SEWAGE DISPOSAL SYSTEM
MARYLAND STATE DEPARTMENT OF HEALTH*

ADDRESS 13775 Triadelphia Road, Glenelg, Md. PHONE 988-9270

SUBDIVISION _____ ROAD 6000 Jerry's Drive LOT _____

RE: Building Permit Application
Serial Number: 45686
Proposed Addition
6000 Jerry's Drive

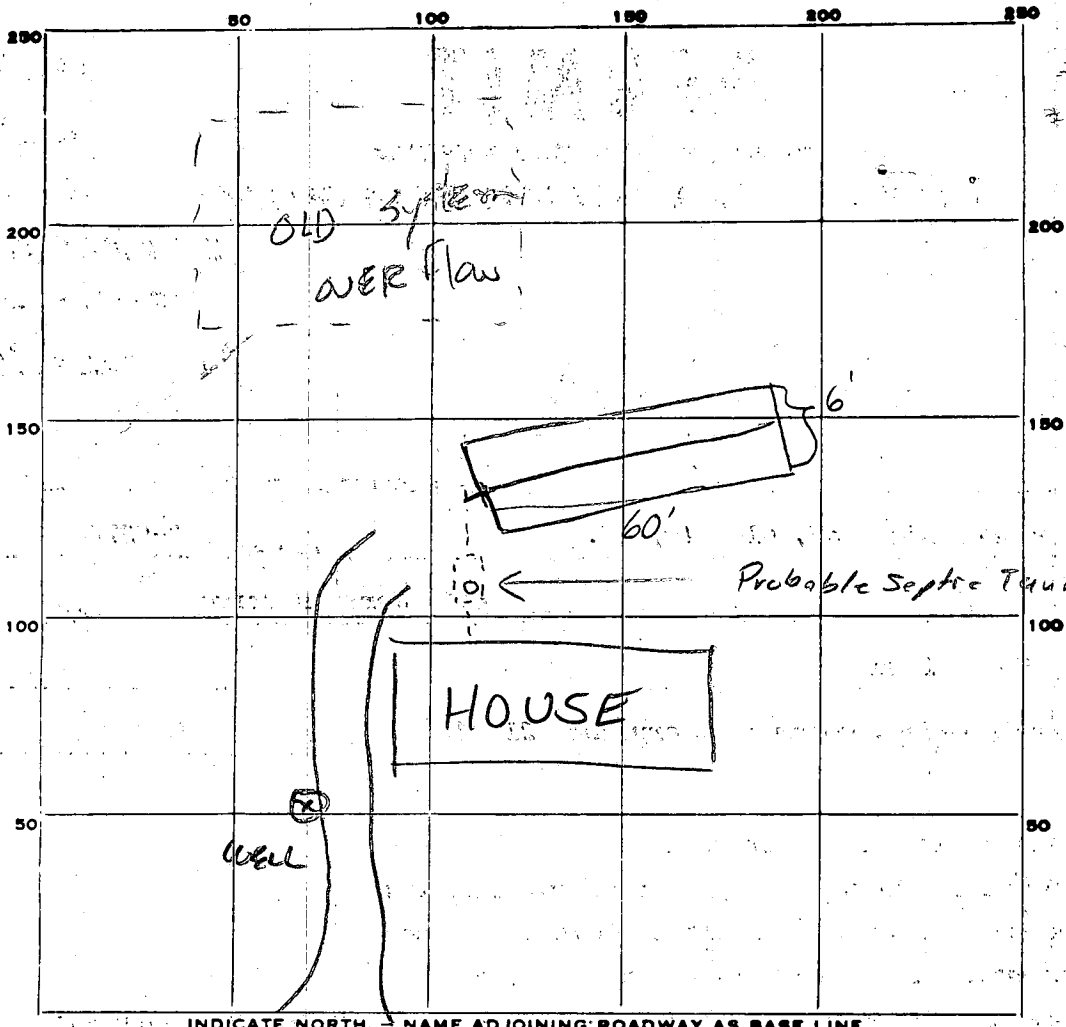
REPAIR - Call for an appointment when ground is opened up and Sanitarian will

recommend the repair system. Trench 6' deep Maximum (shallowen) possible 60' long 6'-7' wide 2' of gravel. SK 3/11/81 old system to be disconnected

REMARKS 1/2/81 OK To add gravel to Trench 511-1
1/2/81 OK to cover all work

Exhibit
 6036 Jerry's Dr. lot
 11-10

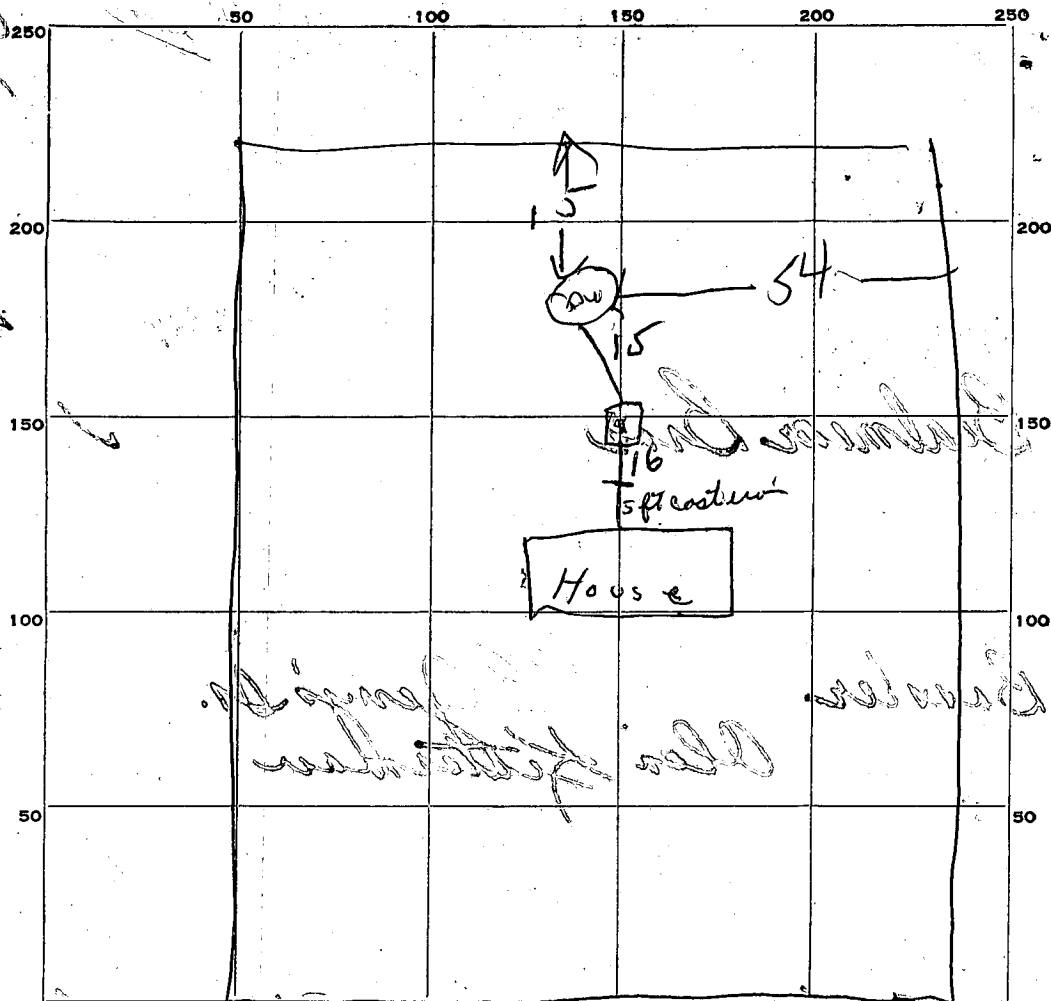
need 3" stand pipe (cleanout)

7/10/63 - OK to cover line from house to septic tank and line
 from Tank to Drivl + the Drivl. need 3" cleanout pipe
 Pipe installed. DJV

DON LYNCH ASSOC., INC. 4907 HARFORD ROAD BALTIMORE, MD. 21214	
Scale: 1" = 50'	Updated 6/10/83 Date: 9/27/80

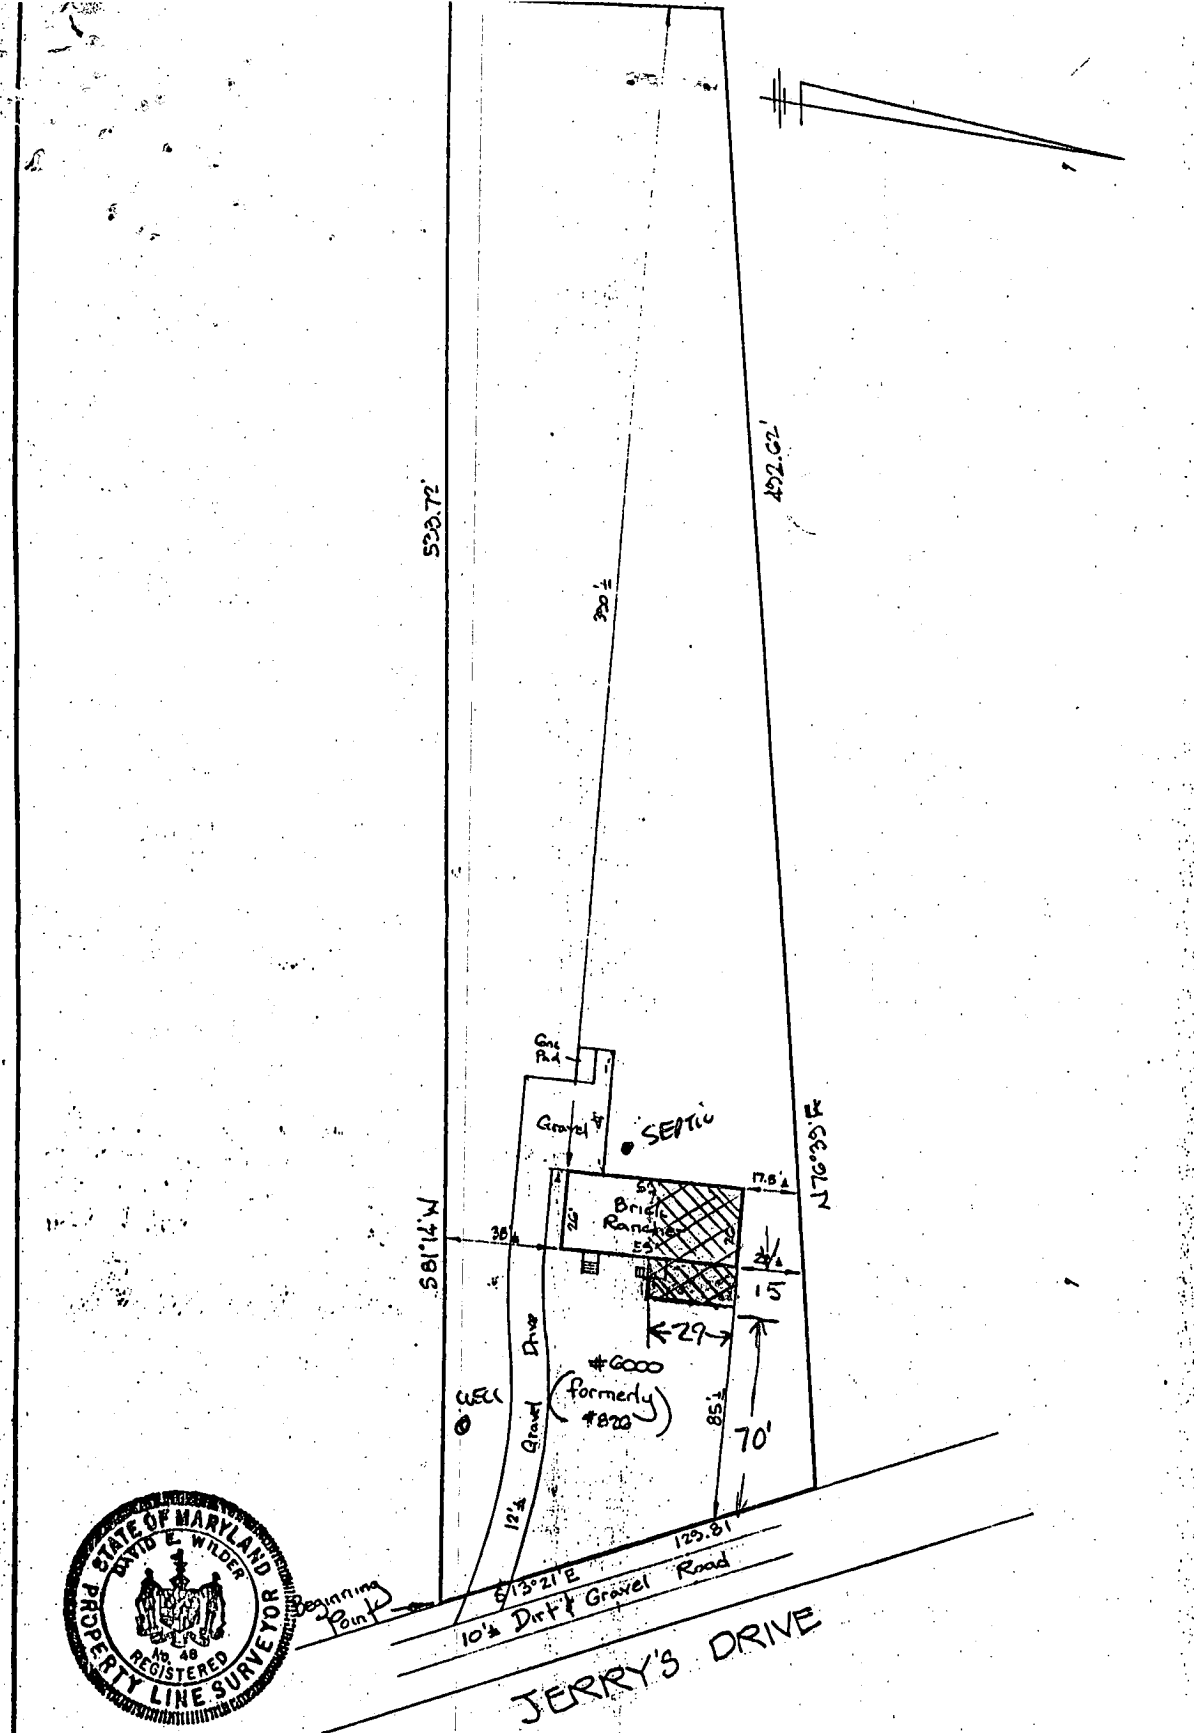
This is to advise that the above referenced building permit application cannot be recommended for approval at this time because of insufficient septic disposal capacity to support the potential increase in wastewater flow associated with the addition. Soil conditions as evidenced by the original percolation test results were marginal at best. This conclusion is reinforced by results from testing conducted in 1981 for repair of the septic system. There is no indication that the system is functioning improperly at this time; but, an expansion of the house size could create a potential stress on the septic system.

Connection to public sewer is the recommended remedy. From discussions with your builder, it is the understanding of this office that public sewer is not currently available, but that plans are underway. If it could be determined (perhaps via letter from the Howard County Bureau of Engineering) that public sewer will definitely be available in the immediate future, then there might be grounds to recommend approval of this permit application at this time.

Conversely, if it is determined that public sewer is not "imminent", then the proposal could be evaluated on the basis of long-term septic capacity. Because of potential for seasonal groundwater interference, percolation testing would be requested to be delayed until the Spring "wet season" to better determine if soil conditions are accepted throughout the year.

RESOLVED
BUREAU OF ENGINEERING
PROVIDES ASSURANCE
PUBLIC SEWER
IS IMMINENT (2 YRS)
LETTER TO FOLLOW
BP RECOMMENDED
FOR APPROVAL
10/26/92
C Williams
